Minutes

Date: February 8, 2017; Revised February 27, 2017
File #: TPB166090
Meeting Date & Time: January 11, 2017
Meeting at: MTO Central Region, 159 William Hearst Avenue, Building D, 7th Floor Boardroom
Subject: McLaughlin Road and E/W Spine Road Class EA Meeting #2 with MTO

Alternative #1

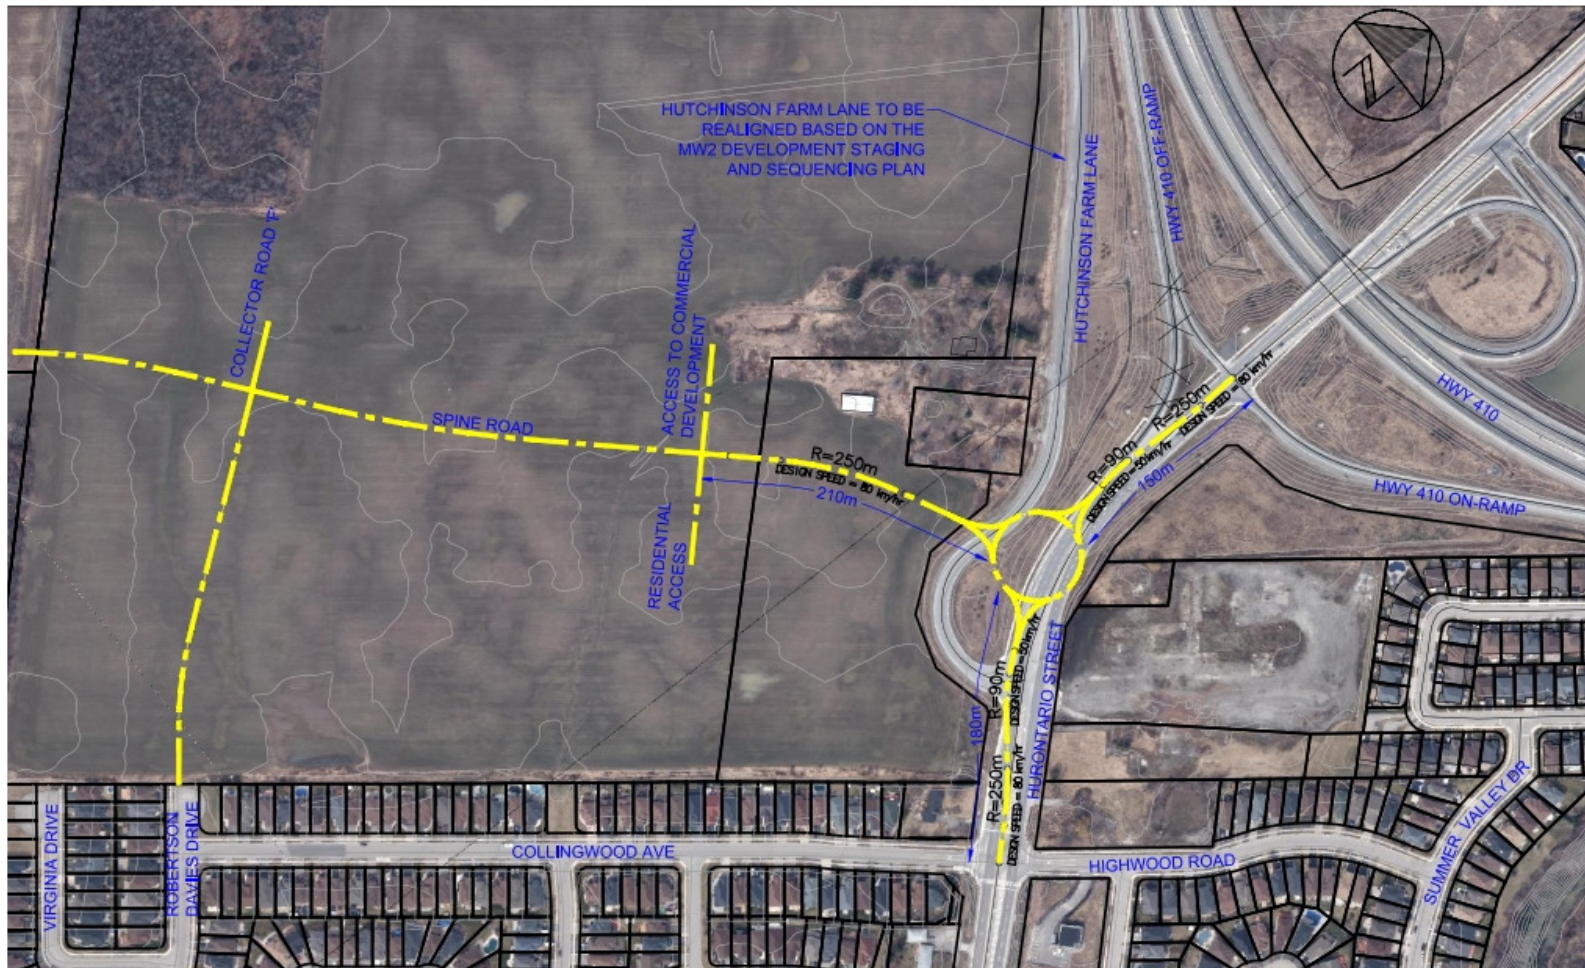
8. Amec Foster Wheeler presented the five alternatives submitted to the MTO in December 2016. The MTO provided detailed comments on the alternatives, as follows:
 - a. Alternative #1 – Not acceptable given signage requirements to ensure proper wayfinding by road users (up to 6 pieces of info needed on signage). This comment was heavily weighted based on past experiences with signage for existing interchange.
 - b. Alternative #2 – Not acceptable as movement to continue northbound is not intuitive. Safety risk for road users unfamiliar with the area, which might continue straight

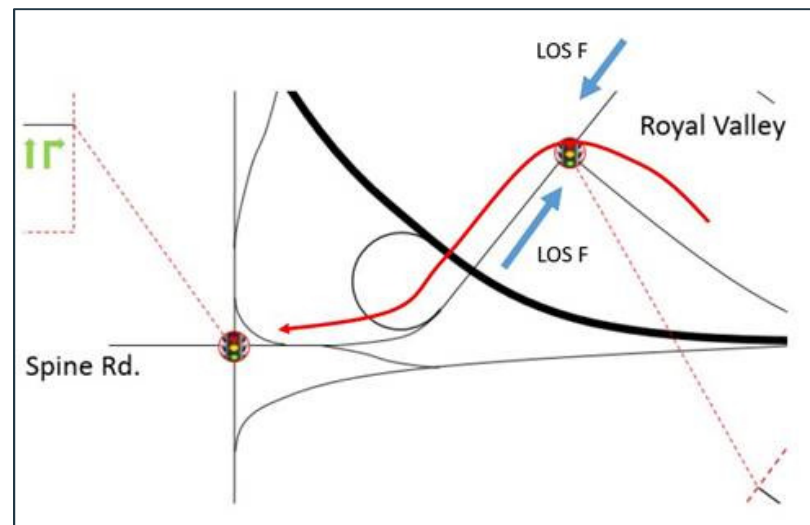
- MTO Traffic has expressed concern with the following movement (shown in red)

Recommendation: Optimize signal timing to give priority to the identified movement
